Re: Submission on Cammeray Seniors Living | SSD-96505456

This submission has been prepared on behalf of Selina Poyner, the owner of 27 Rosalind Street Cammeray, which immediately adjoins the proposed seniors housing development to the east. The purpose of the submission is to raise concerns with various aspects of the proposal.

Figure 48 indicative residential flat building siting at 27 and 29A Rosalind Street

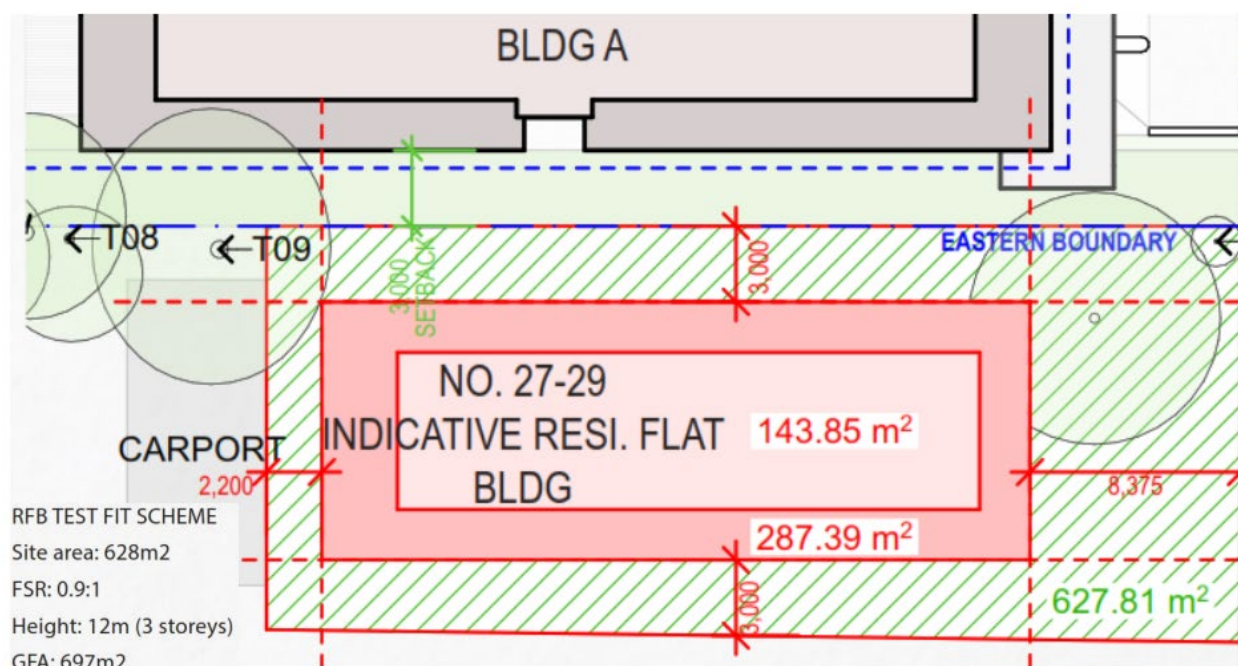
The indicative residential flat building envelope submitted by the applicant inadequately demonstrates that either one or both adjoining semi-detached dwelling sites are reasonably capable of being developed for a residential flat building. The plan assumes a 3m side setback to the east and west which does not comply with the ADG side setbacks that would apply. The indicative envelope does not demonstrate that both the subject site and 27 and 29 Rosalind Street both individually or together could achieve a development that is consistent with the planning controls and result in appropriate built form with acceptable level of amenity.

On the basis of the EIS's assumption that this clause applies to the proposal, it has failed to demonstrate that the adjoining site at 27 Rosalind Street can achieve a residential flat development consistent with the applicable planning controls including an appropriate urban form and with an acceptable level of amenity, in order for the consent authority to be satisfied under the requirements of clause 6.12 of the NSLEP 2013.
